**ADDENDUM #1 TO THE
TECHNICAL DRAINAGE STUDY
FOR RANCHO MULTI FAMILY PHASE 2**

**RE: Rancho Multi Family Phase 2
DS5583**

The purpose of this letter is to address the comment letter dated July 13, 2022 regarding the above-referenced project. The comments are individually addressed. Each comment has been re-typed with the response to each comment.

CITY OF LAS VEGAS INTER-OFFICE MEMORANDUM		DATE: July 13, 2022
TO: Land Development Services Department of Building & Safety		FROM: Albert Sung, P.E. Flood Control Project Engineer Department of Public Works
SUBJECT:	Drainage Study for: Rancho Multi Family Phase 2	
Cross Streets:	NWC of Rancho Drive & Smoke Ranch Rd.	COPIES TO: RCI Engineering
File Number:	F:\Depot\DSMemos\DS5583A.doc	Nola Sol Holdings, LLC
Parcel Number:	139-18-410-017	Bart Anderson, P.E., DevCo
Zoning Action:	EOT-78774 on SDR-73295	CCRFCD
FEMA Flood Zone	YES	CNLV
Proposed Storm Drain	YES	NDOT
	NO	X
	NO	X

RANCHO MULTI-FAMILY PH 2
EDWARD HOMES
FIGURE 10
BMP EXHIBIT

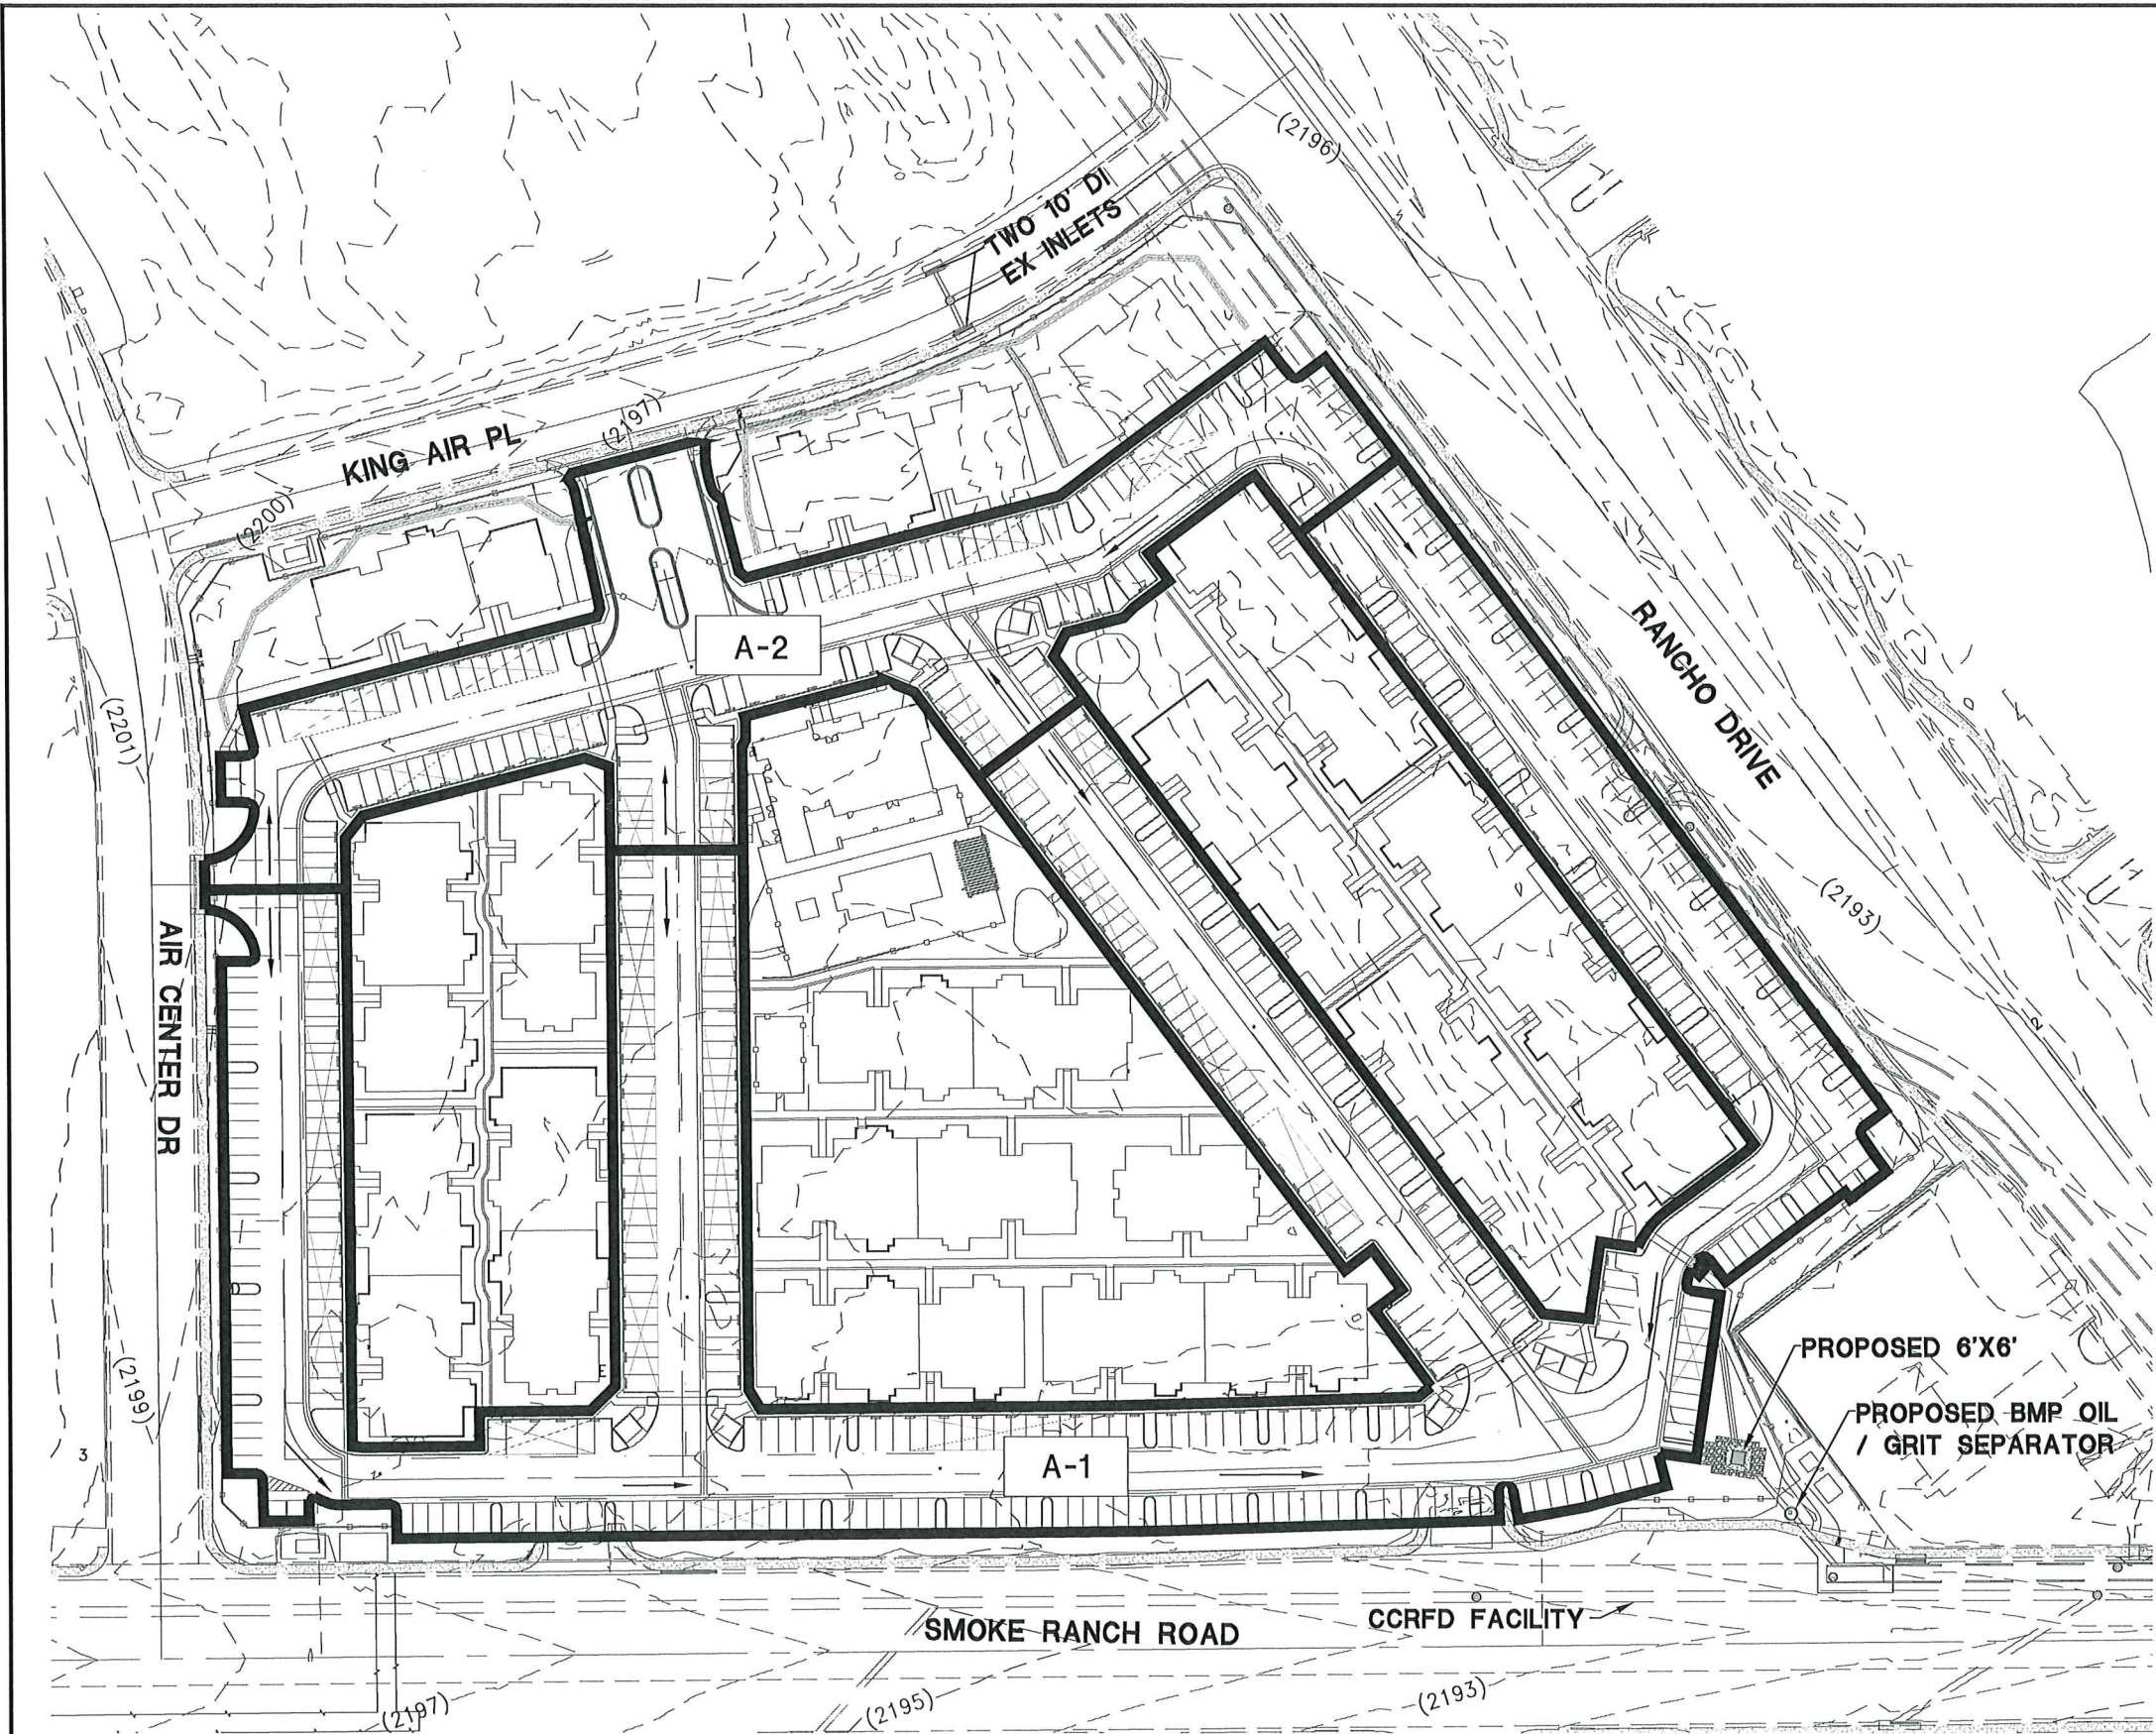
Comment 13: The overall parking lot improvement area is larger than 1 acre. Per **Section 1500** of the *Clark County Regional Flood Control District's Hydrologic Criteria and Drainage Design Manual*, the subject improvements must provide for Low Impact Development (LID) measures. Review and address the issue in the next submittal.

Response: The total area of the parking lot is about 4.9 acres of which 3.63 acres drains to a proposed BMP OIL / Grit Separator near the southeast corner of the site. Figure 10, provided in Appendix A, is a BMP Exhibit that shows the areas of parking lot that drain to the BMP. Calculations to determine the size of Oil / Grit Separator is provided in Appendix B. The Oil / Grit Separator detail is provided in the detail sheet of the improvement plans.

CONTECH
PROPOSAL
DRAWING

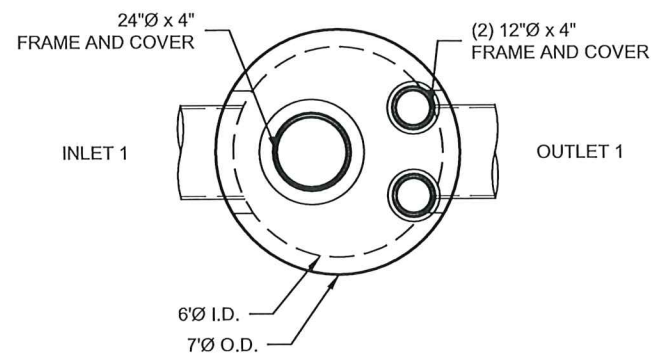
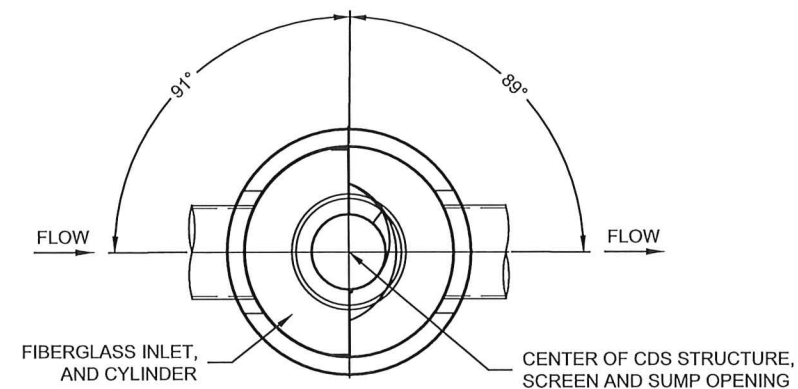
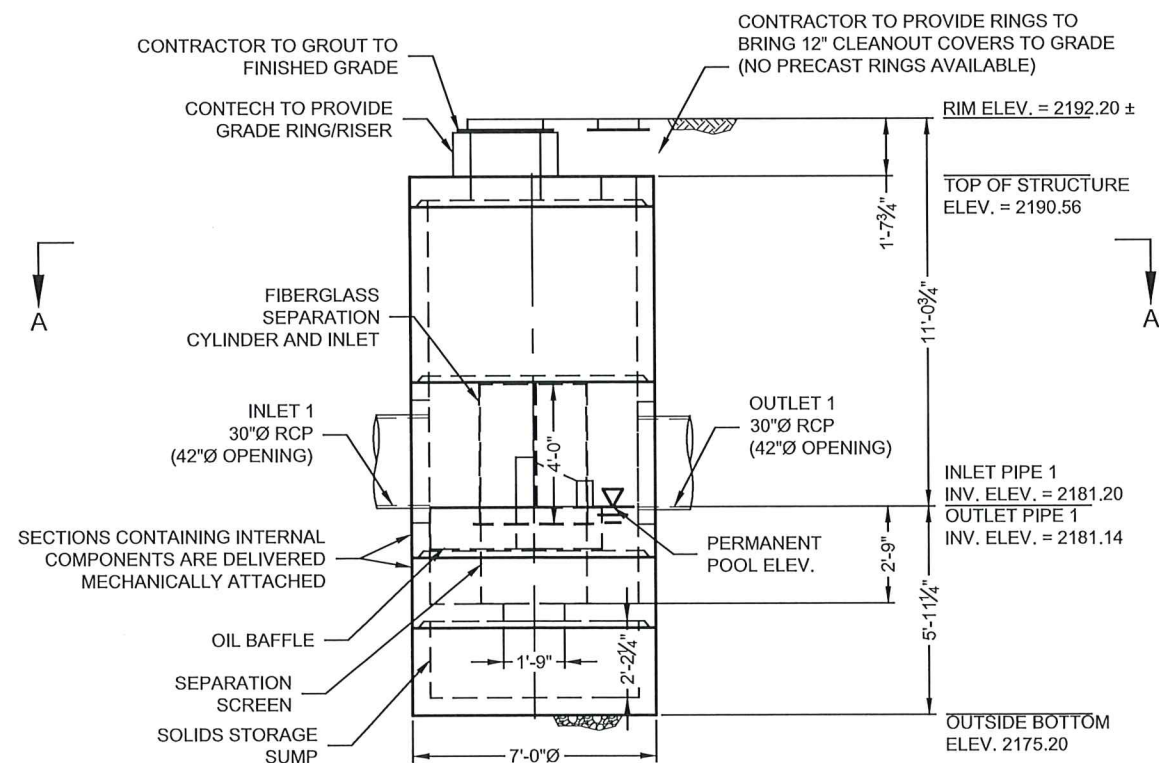
Comment 7: Sheet C2.6: Provide a storm drain manhole at the 30"-RCP behind the property line to distinguish public/private maintenance responsibility post development.

Comment 8: Sheet C2.6: Provide a storm drain manhole at the connection point of the 30"-RCP and the extended new regional box. Revise all pertinent plans and details accordingly.

Response: The improvement plans were revised to provide an oil / grit separator behind the property line to distinguish public / private maintenance responsibility. The oil / grit separator and onsite storm drain will be privately maintained. The offsite storm drain, downstream of the oil / grit separator, will be publicly maintained.
